CITY OF ALBUQUERQUE
PUBLIC WORKS DEPARTMENT

COPPER PARK SUBDIVISION GRADING & DRAINAGE PLAN

RECEIVED OCT 27 2004 HYDROLOGY SECTION

CONCRETE CHANNEL SECTION

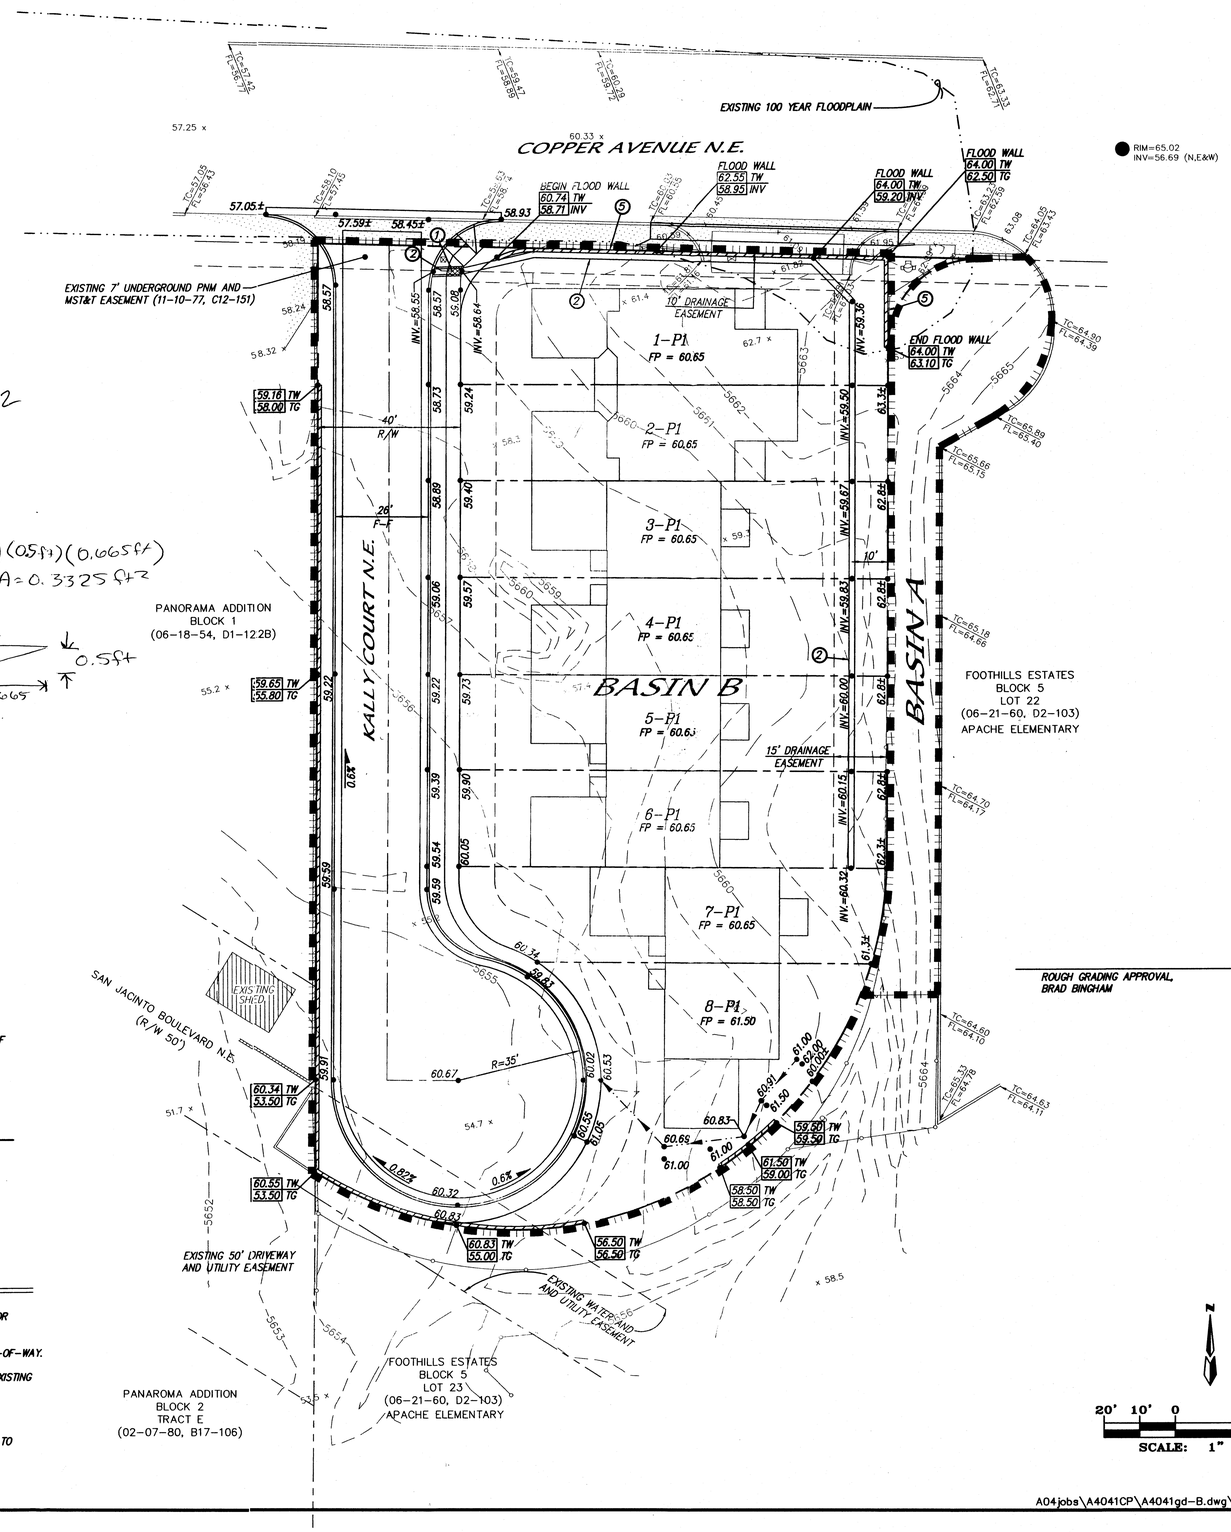
Calc of channel capacity?

prev design $A = 2(\frac{1}{2})(0.55ft)(0.665ft)$

$A = 0.3325\ ft^2$

$A = (0.33ft)(20in)\left(\frac{1ft}{12in}\right)$

$A = 0.55\ ft^2$

$R = \frac{A}{WP} = \frac{0.55ft^2}{0.33 + 1.667 + 0.33}$

$R = \frac{0.55}{2.33} = 0.236$

Assume S still = 0.006

Assume n = 0.012 (finished concrete)

$Q = \frac{1.49}{n} A R^{2/3} S^{1/2}$

$Q = \frac{1.49}{0.012}(0.55)(0.236)^{2/3}(0.006)^{1/2}$

$Q = 2.02\ cfs$

if unfinished concrete, n = 0.014

$Q = 1.73\ cfs$

$Q_{req} = 0.93\ cfs$
